Spartanburg School District 2 RFQ1903 Fitness Trail Paving at Oakland Elementary

ADDENDUM 1

August 7, 2018

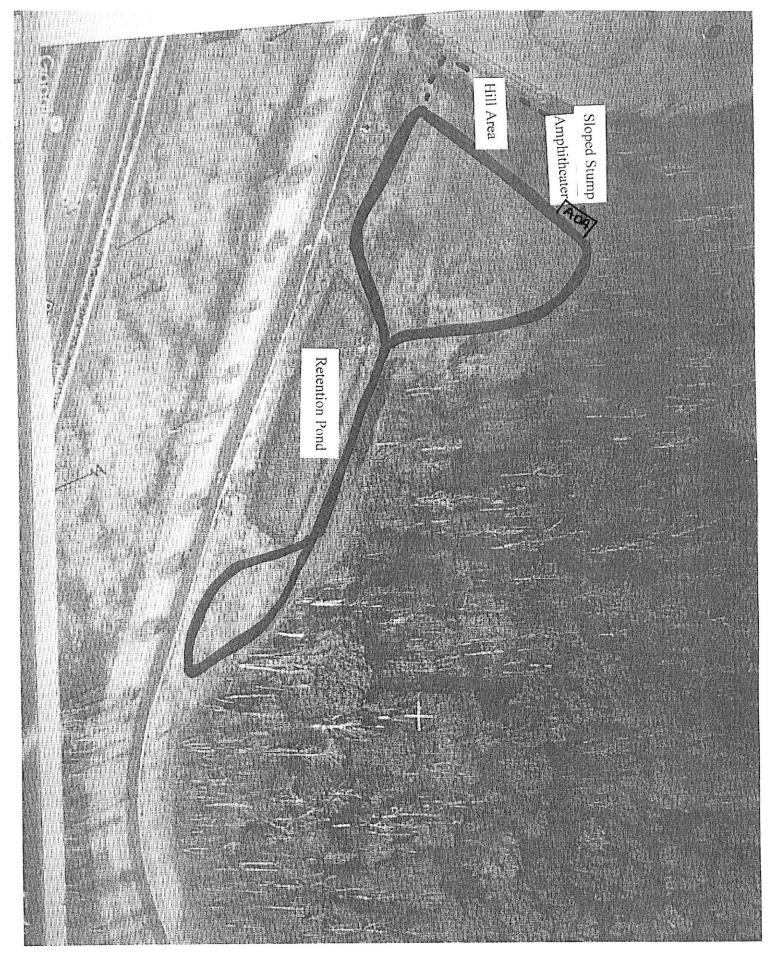
- 12. After the pre-bid, it was determined that there will be an alternate bid. The base bid will include the entire project as discussed at the pre-bid. The alternate bid will only include the large loop portion of the trail, the ADA pad and the grading for the amphitheater and will eliminate the trail over the dam and the small teardrop loop. Please see revised drawings and bid proposal sheet.
